PLAN COMMISSION MEETING NOTICE AND AGENDA Tuesday, March 15, 2022 6:00 PM

REPORT TO THE PLAN COMMISSION

Date: February 25, 2022
To: Caroline Brzezinski, Interstate Partners
From: Nick Fuchs, Planner & Community Development Director
RE: Staff Comments – Ridgeview Apartments development

SHEET NUMBER:
L-100

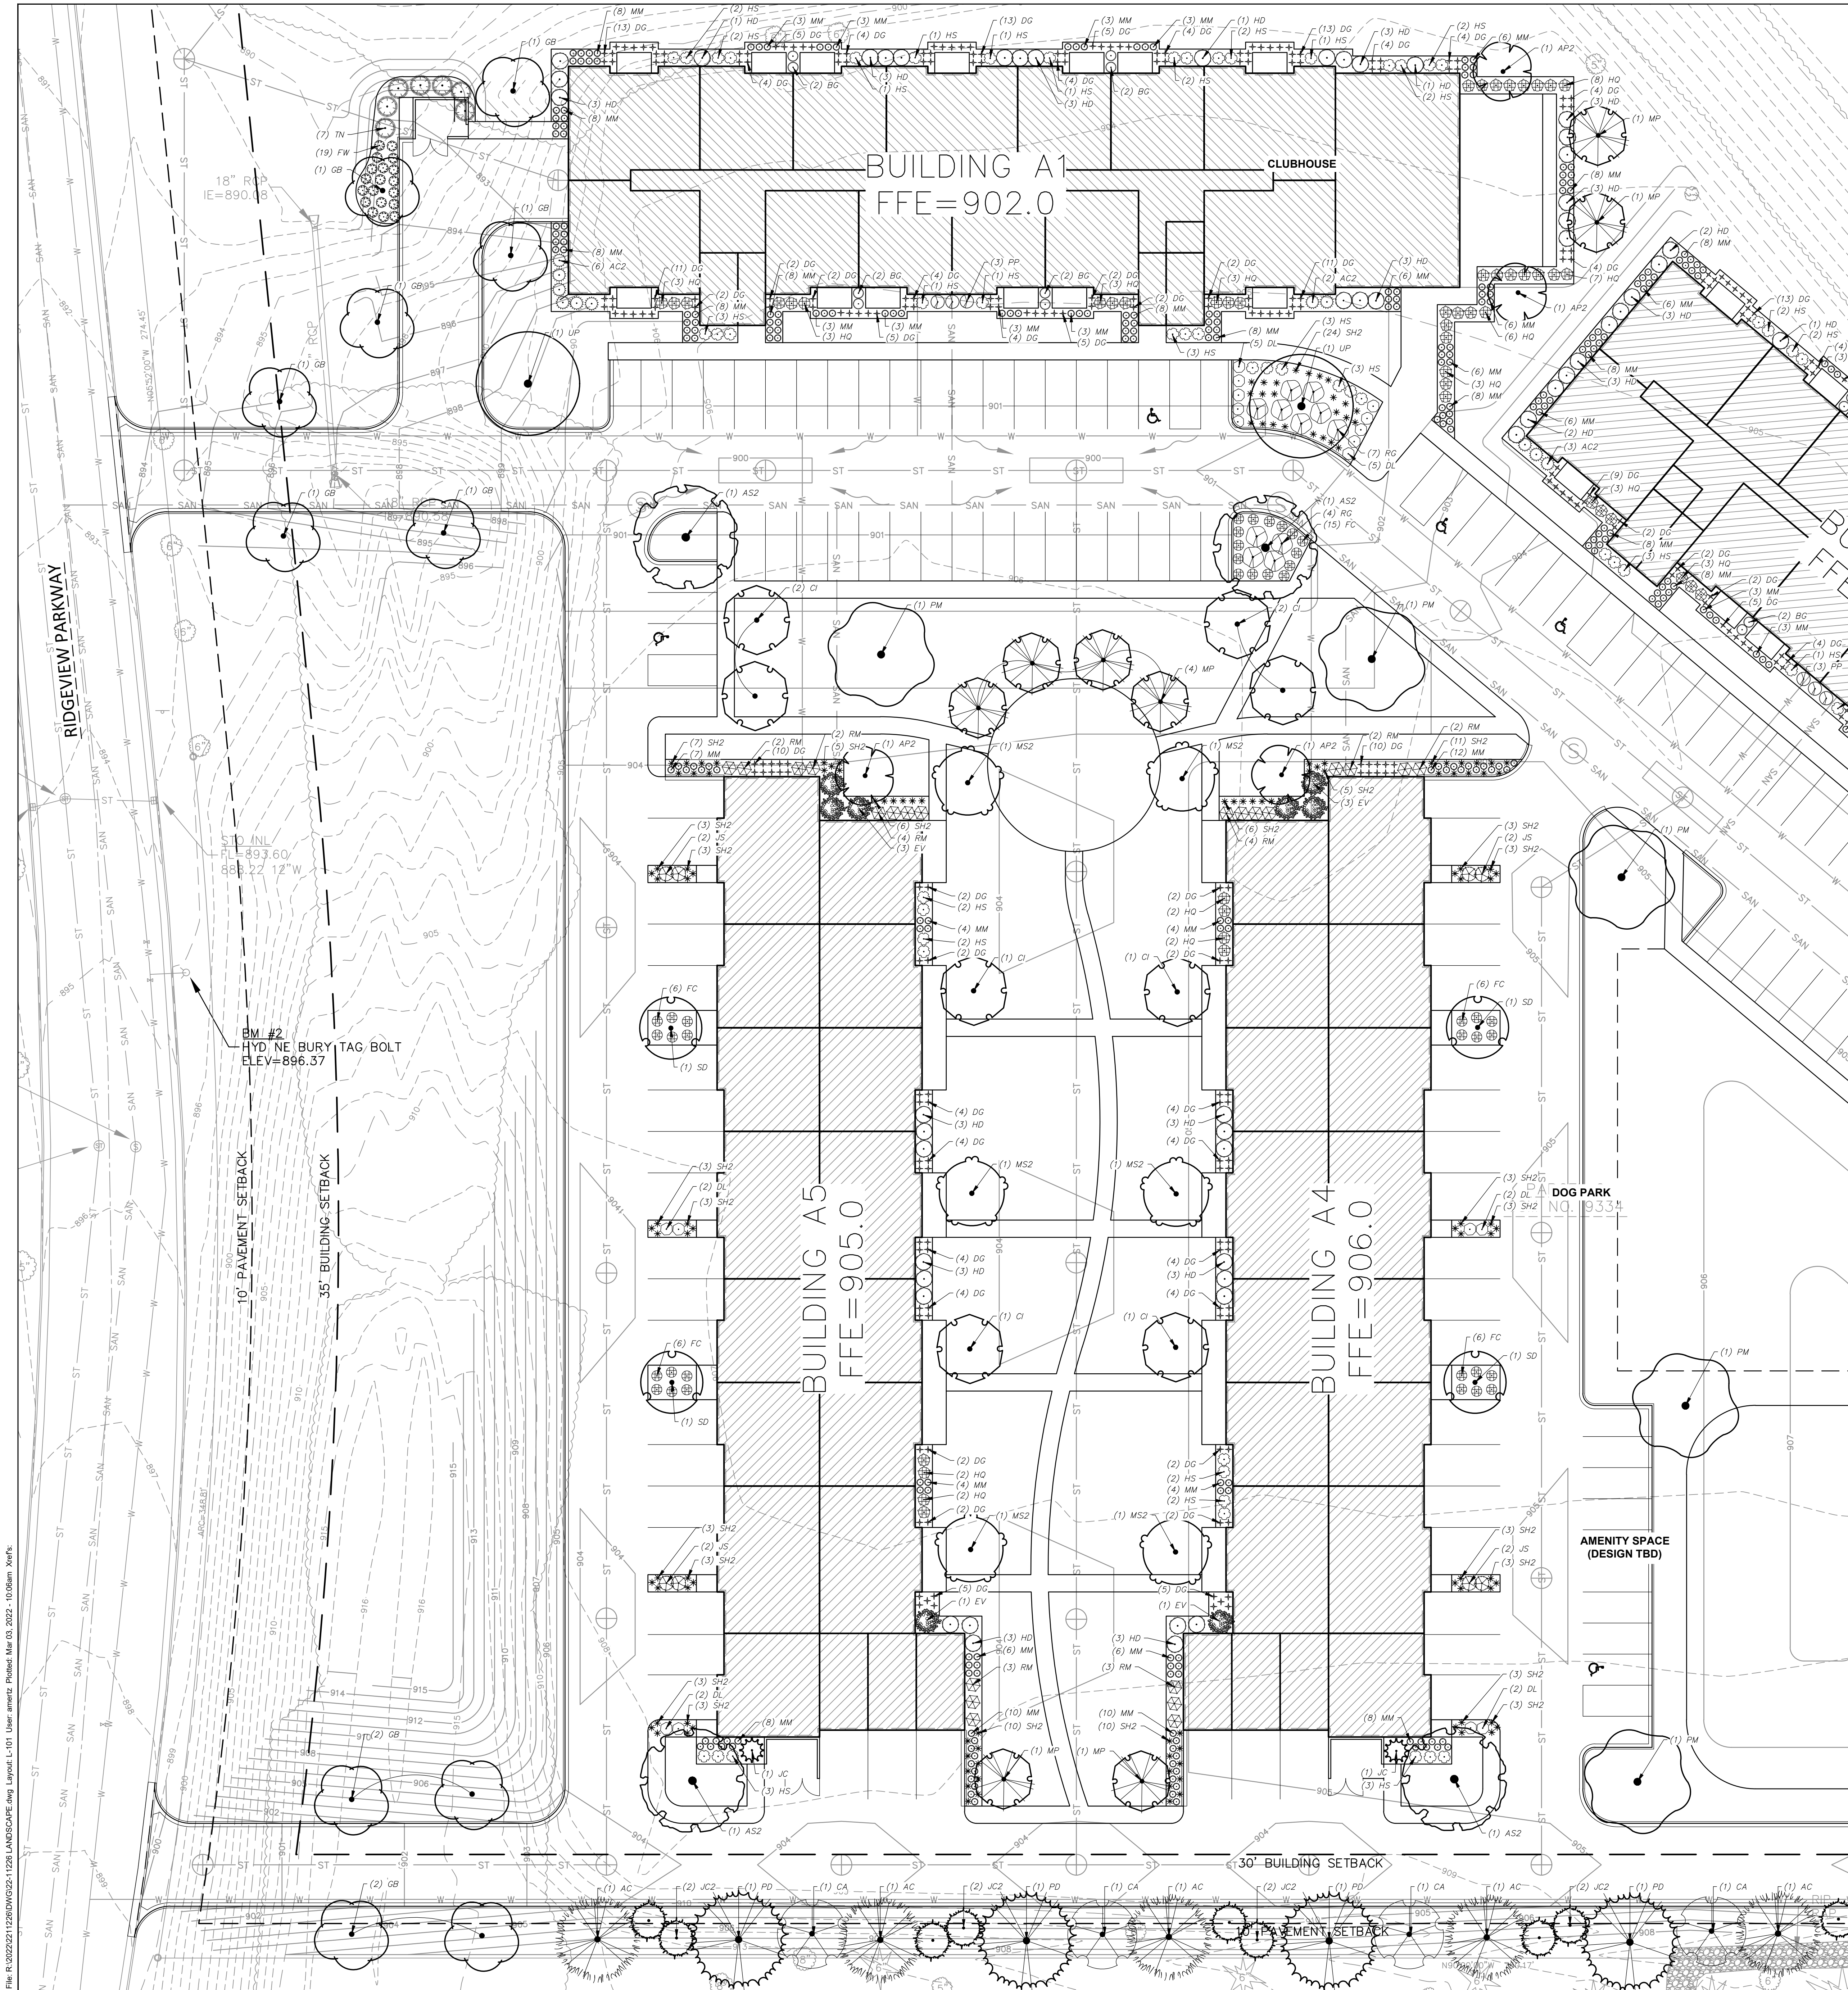
The Landscape Plan illustrates the areas of the site that will be disturbed and the existing treed areas to be preserved. In addition to the existing trees, the Landscape Plan includes 28 ornamental trees, 30 shade trees, 25 evergreen trees, and 440 shrubs.

Staff is recommending that following tree removal and installation of landscaping onsite, the applicant and City staff shall review landscaping and tree lines, particularly along the perimeter of the site where the backs of buildings and/or overhead doors may be visible from public rights-of-ways, to ensure that screening is sufficient. If the new and remaining plantings do not provide appropriate screening as determined by staff or the Plan Commission, the applicant shall provide infill plantings, as reasonably practicable at the direction of staff or the Plan Commission.

11. It is also recommended that the landscape plan clearly shows areas of the existing trees that will be preserved and an indication of those areas where tree removal will occur, if any.
